DEPARTMENT OF PUBLIC WORKS
COUNTY OF HUMBOLDT

LAND USE DIVISION INTEROFFICE MEMORANDUM

RE: SUBDIVISION REQUIREMENTS - IN THE MATTER OF THE VALADAO, APPLICATION # PLN-2021-17560 FMS, APN 510-381-021, FOR APPROVAL OF A TENTATIVE MAP, CONSISTING OF 2.47 ACRES INTO 19 LOTS

These recommendations are based on the tentative map prepared by Kelly-O’Hern dated April 2023, revised December 29, 2023, and dated as received by the Humboldt County Planning Division on December 29, 2023.

Above: Typical section for widening Pickett Road

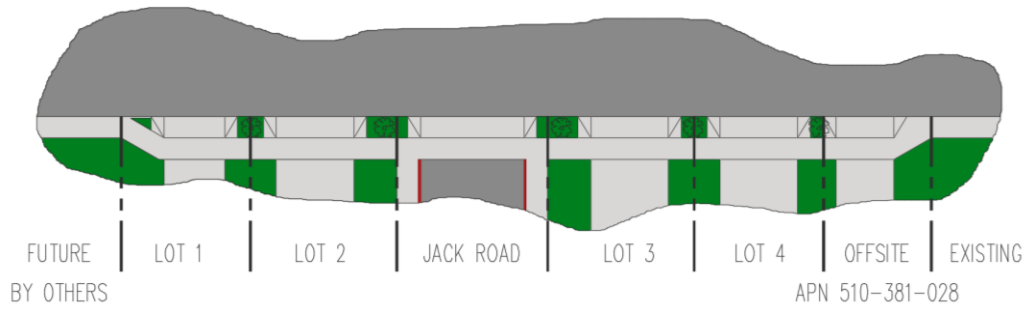
- (a) **Pickett Road (County Road No. 4M030)** shall be constructed having a typical section comprised of two 12 foot wide driving lanes, an 8 foot wide parking lane, a 5' wide landscape strip (4.5' wide useable) and 5' wide pedestrian sidewalk with Caltrans Type A2-6 portland cement concrete (PCC) curb and gutter fronting the subject parcel.

Above: Plan view of Pickett Road widening and Jack Way intersection

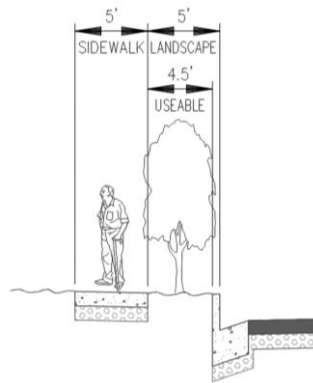
- (a) A stop sign shall be installed on Jack Way at its intersection with Pickett Road. A stop sign shall be installed on Jack Way at its intersection with Gwin Road. When the road is paved, a "stop" pavement marking and limit line shall be installed.

At its intersection with Pickett Road and at its intersection with Gwin Road, construct Urban Dwy No. 1.

Above: Typical section for widening Gwin Road

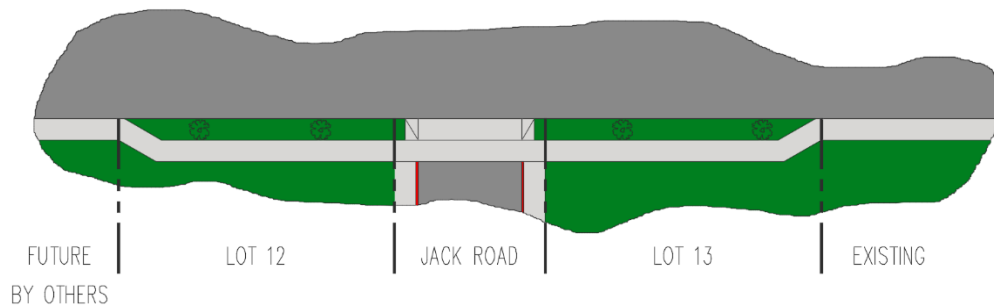
- (b) **Pickett Road (County Road No. 4M030) OFFSITE:** construct in fill curb, gutter, sidewalk, and urban driveway No. 1 across the frontage of APN 510-381-028. (This was the former access to the subject property.)
- (c) **Gwin Road** shall be constructed having a typical section comprised of two 12 foot wide driving lanes, an 8 foot wide parking lane, a 5' wide landscape strip (4.5' wide useable) and 5' wide pedestrian sidewalk with Caltrans Type A2-6 portland cement concrete (PCC) curb and gutter fronting the subject parcel.

Above: Typical section for Jack Way

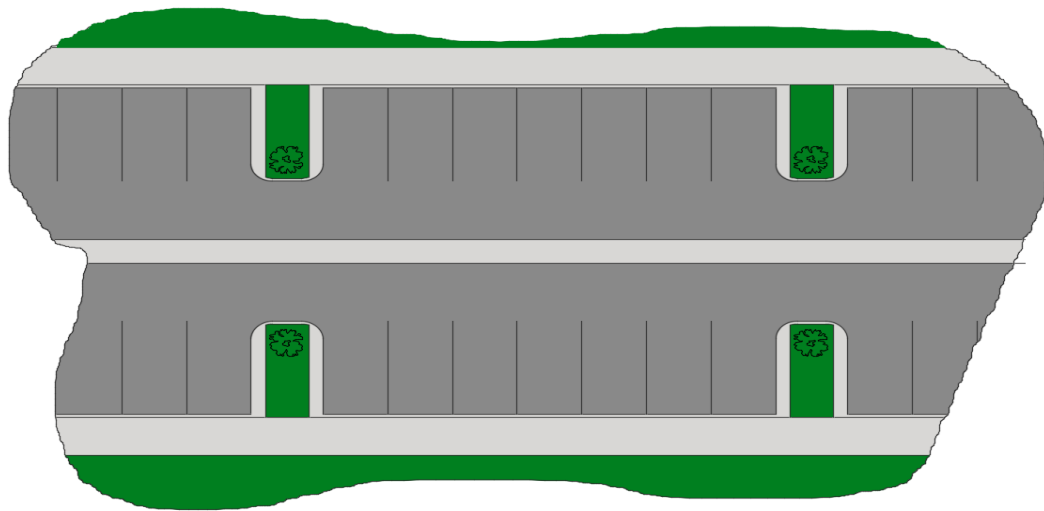
- (d) **Jack Way** shall be constructed 24' in width with a 3' wide concrete valley gutter in the center of the roadway. A 5' wide sidewalk shall be provided along both sides of the road. Where parking stalls are provided, the road shall have a 16' deep parking stall with Caltrans Type A1-6 curb and 7 foot wide sidewalk.

Parking stalls shall be a minimum of 9 feet wide in order to utilize a 24 foot wide roadway. A wider roadway is necessary if narrower parking stalls are desired.

The road is not designed for on-street parallel parking. In all areas where perpendicular parking is not provided, the curb shall be painted red or otherwise posted for no parking.

Where perpendicular parking is provided, provide landscaped medians periodically.
